UNITED STATES PATENT AND TRADEMARK OFFICE

APPLICATION NO.	FILING DATE	FIRST NAMED INVENTOR	ATTORNEY DOCKET NO.	CONFIRMATION NO.
10/813,069	03/31/2004	Rudolf Moller	32368-199846	5288

Office Action Summary

DETAILED ACTION

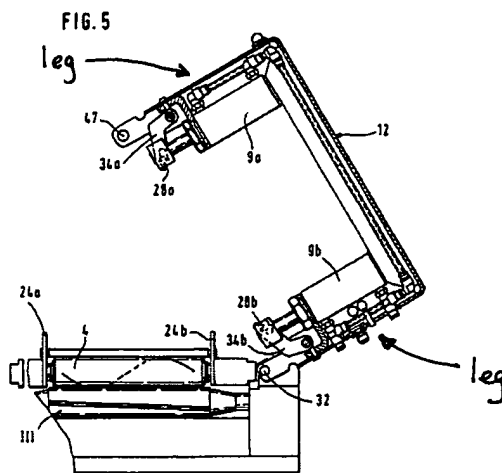
Roder discloses a double pressure cylinder arrangement having a first pressure cylinder 9a, a second pressure cylinder 9b positioned in a spaced and axis-parallel relationship to the first pressure cylinder 9a, a carrier strut 12 having a hollow intermediate section (see figure below) connected to the bottom side of the first pressure cylinder 9a and the second pressure cylinder 9b, a substantially u-shaped housing element (see figure below) having two leg sections wherein each leg section houses one of the pressure cylinders (9a, 9b) and connection lines (see figure below) for driving the first pressure cylinder 9a and the second pressure cylinder 9b integrated in the intermediate section.

With regard to claim 5, a fluid connection supplies fluid to the first pressure cylinder 9a and to the second pressure cylinder (see figure above; Col. 6, lines 61-65).
